**TOWN OF WINDSOR
BOARD RESOLUTION 2015-54**

**RESOLUTION APPROVING
FINAL PLAT OF BEAR TREE FARMS,
SUBMITTED BY BEAR TREE FARMS, INC.**

TO: Town of Windsor Board
CC: Robert Wipperfurth, Chairman
Tina Butteris, Office Manager
Amy Anderson Schweppe, Planning & Development Coordinator
Kevin Richardson, Engineer
Connie Anderson, Attorney
FROM: Jamie Rybarczyk, Planning Consultant
RPT DATES: June 08, 2015
MTG DATES: June 18, 2015
APRVL DATE: June 19, 2015
FOTH FILE: 15W027.01/09
RE: Bear Tree Farms (Windsor) – Final Plat

Scale: 1" = 200'
 SHEET 1 of 7

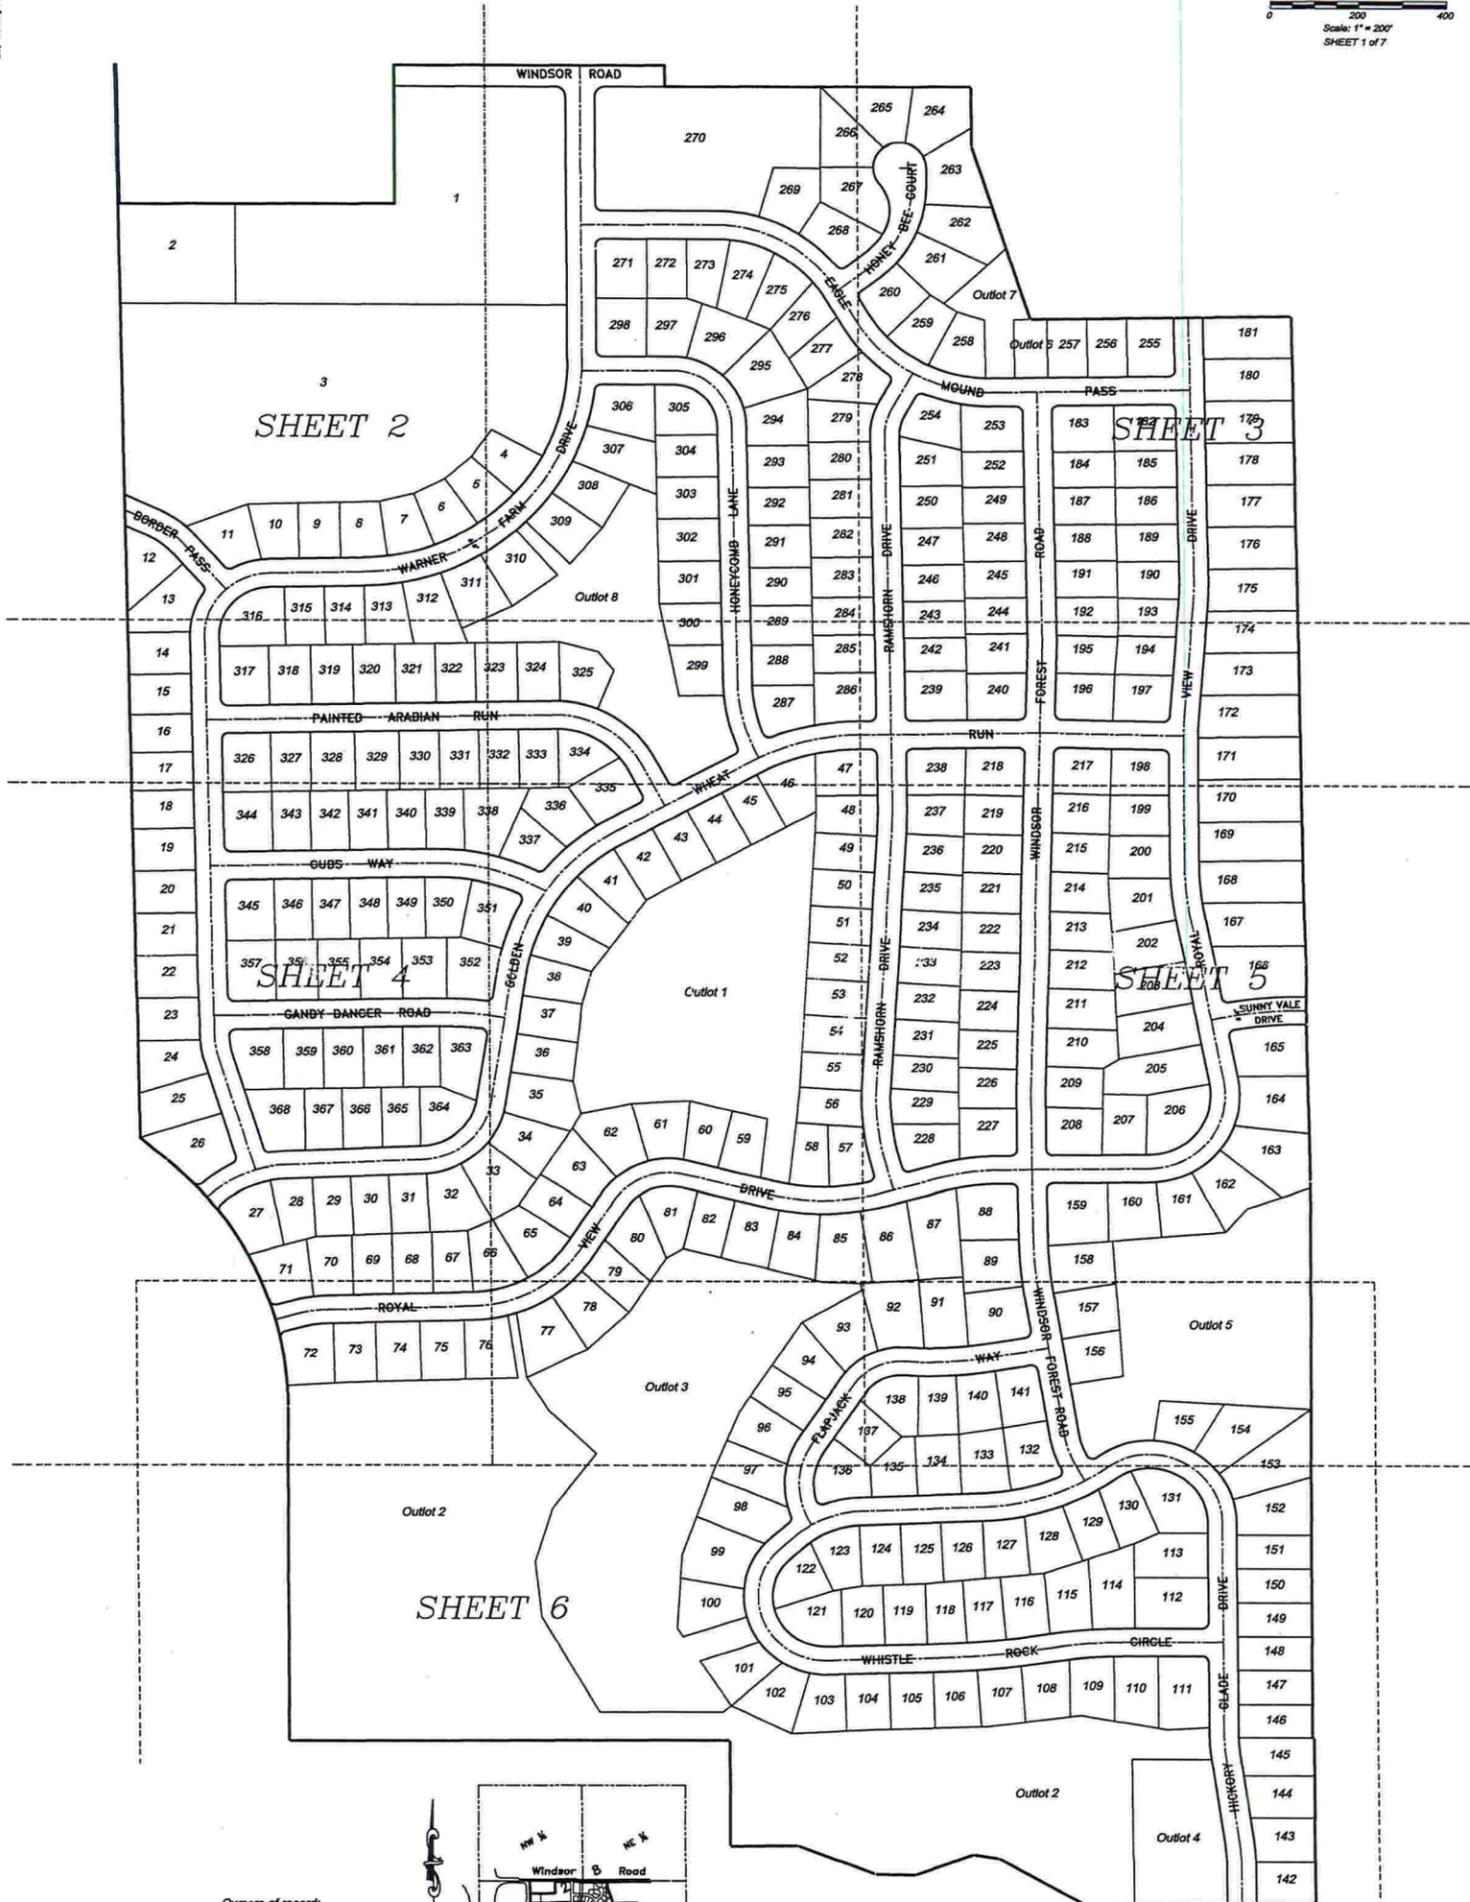
2. Prior to recording the Final Plat, the petitioner shall choose an alternative name for Windsor Forest Road.
Planner Note: Windsor Forest Road has been renamed to Grouse Woods Road on all the Plat Sheets except the Cover Sheet.
